Access Compliance Report

Public Rights-of-Way

(Curb Ramps)

Intersection ID: 18052	Main Street: RANDOLPH_RD	Cross Street: GAYNOR_RD	Location: NE
ADA ID: BE0AEAC2293B	Ramp Type: PerpDiag	Initial Pass/Fail: Fail	Overall Compliance: No
		Severity Score: 22.5

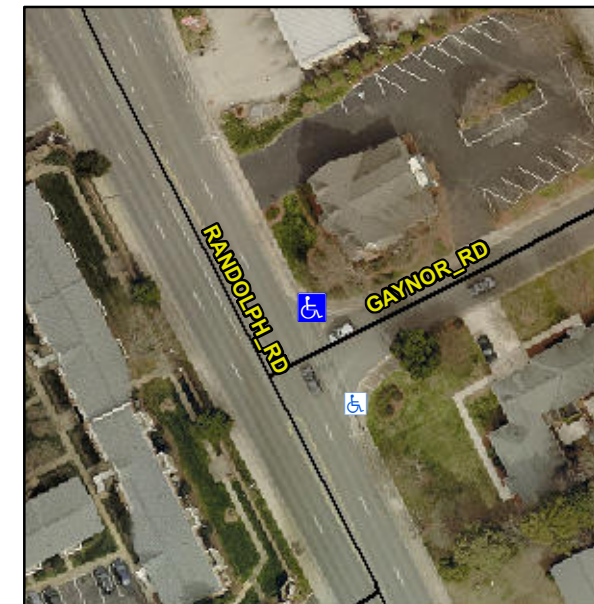
Not Found, R304.5.1, R304.2.2, R304.5.3

Compliance	Description	Data	Compliance	Description	Data
N/A	Ramp Length (in)	74.0	No	Ramp Slope (%)	9.8
No	Ramp Width (in)	36.0	No	Ramp XSlope (%)	2.3
N/A	Flare Type LT	N/A	N/A	Flare Type RT	N/A
N/A	Flare Slope LT (%)	N/A	N/A	Flare Slope RT (%)	N/A
N/A	Flare Traversable LT?	N/A	N/A	Flare Traversable RT?	N/A
N/A	Landing Length (in)	N/A	N/A	DWS Provided?	N/A
N/A	Landing Width (in)	N/A	N/A	DWS Contrast?	N/A
N/A	Landing Slope (%)	N/A	N/A	DWS Length (in)	N/A
N/A	Landing X Slope (%)	N/A	N/A	DWS Full Width?	N/A
N/A	Landing Curb? (Y/N)	N/A	N/A	DWS Offset (in)	N/A
N/A	Shared Landing?	N/A			
N/A	Gutter Ponding?	N/A	N/A	Gutter Slope (%)	N/A
N/A	Gutter Lip Ht (in)	N/A	N/A	Gutter X Slope (%)	N/A
N/A	Painted X Walk1?	No	N/A	Painted X Walk2?	No
	X Walk 1 Direction	To SW		X Walk 2 Direction	To SE
N/A	X Walk 1 Width (in)	N/A	N/A	X Walk 2 Width (in)	N/A
	X Walk 1 Slope (%)	1.6		X Walk 2 Slope (%)	2.3
	X Walk 1 X Slope (%)	3.8		X Walk 2 X Slope (%)	1.3

Remove & Replace Curb Ramp With Two New Directional Ramps or Equivalent.
